DAWN MINING COMPANY
PO BOX 25
FORD, WASHINGTON 98013

TO: W. A. Humphrey, Vice President Operations
FROM: J. E. Thompson, Resident Manager
Re: Preoperational Monitoring Program
Heap Leach Plant Site

PREOPERATIONAL RADIOLOGICAL SITE SURVEY
PROPOSED HEAP LEACH PLANT
DAHL MINING COMPANY

AUXILIARY LEGEND
FIGURE 4
RADON GAS SAMPLING SITES
SITE B LOCATED @
TUM TUM, WASHINGTON

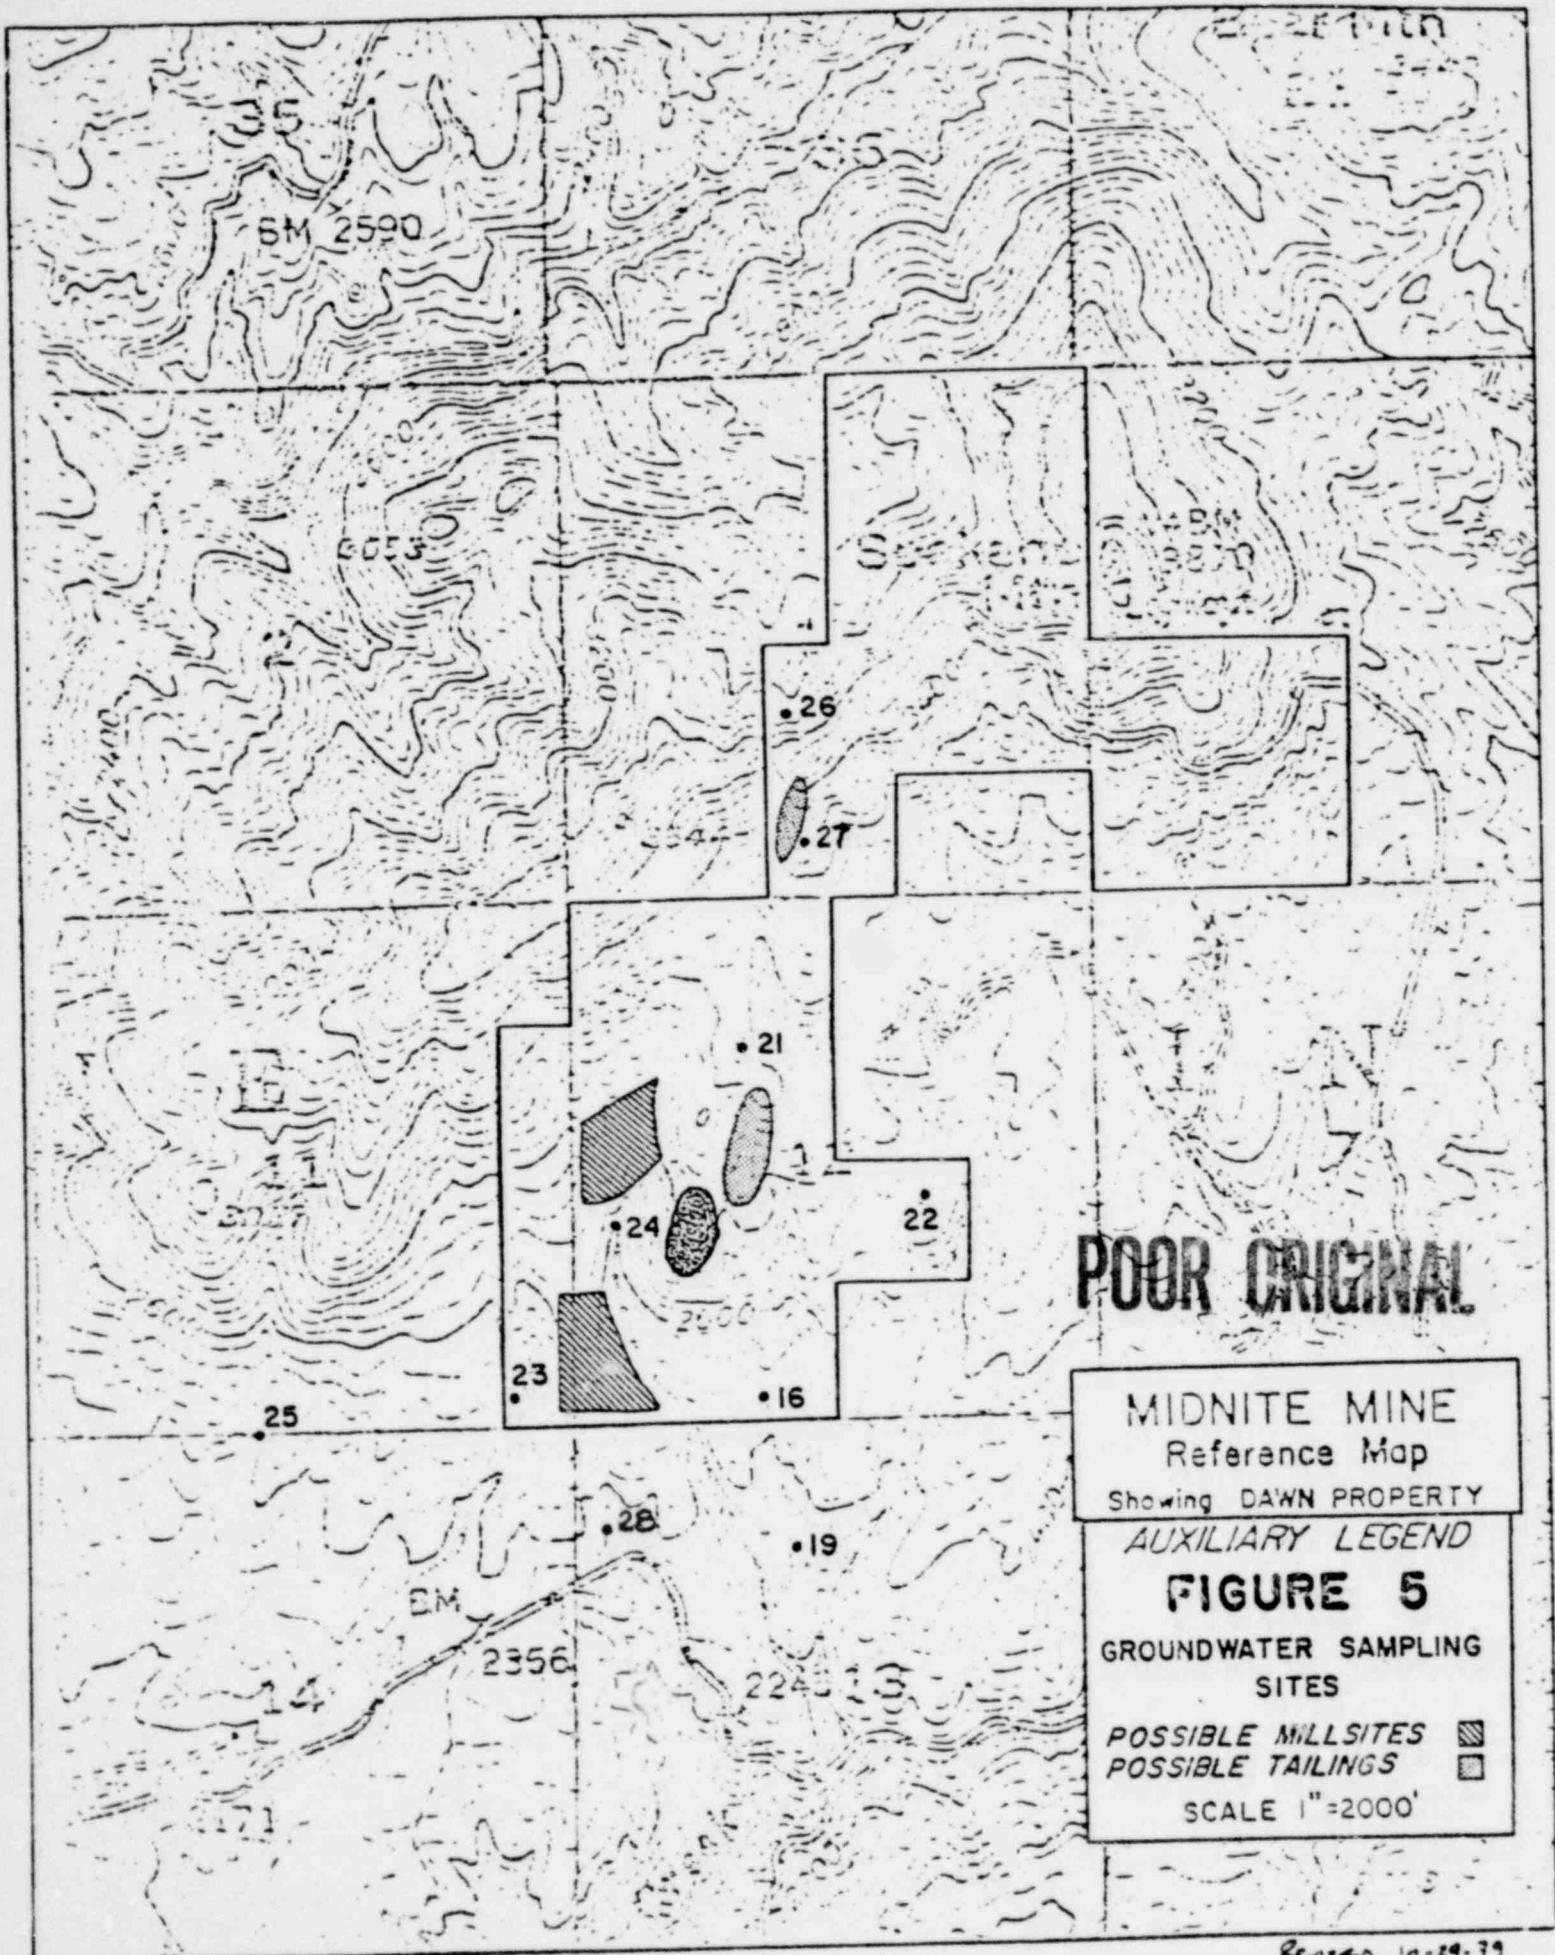
- 1) Two additional ground water monitoring wells have been added. (No's 27 and 28). In addition the suggestion was made to document trace metal (eg. selenium, molybdenum, arsenic, etc.) concentrations in ground waters. This will be done on a quarterly basis.
- 2) The vegetation sampling sites have been moved so that all are downwind from the proposed operation.
- 3) Radon flux measurements will be made by traditional methods (charcoal canisters). Dawn does not have the manpower to conduct a quality assurance program to validate the Polonium 210 method originally proposed.
- 4) Additional monitoring has been provided around the proposed Pit 4 tailings disposal site. A radon gas monitoring station and a ground water monitoring well have been added.
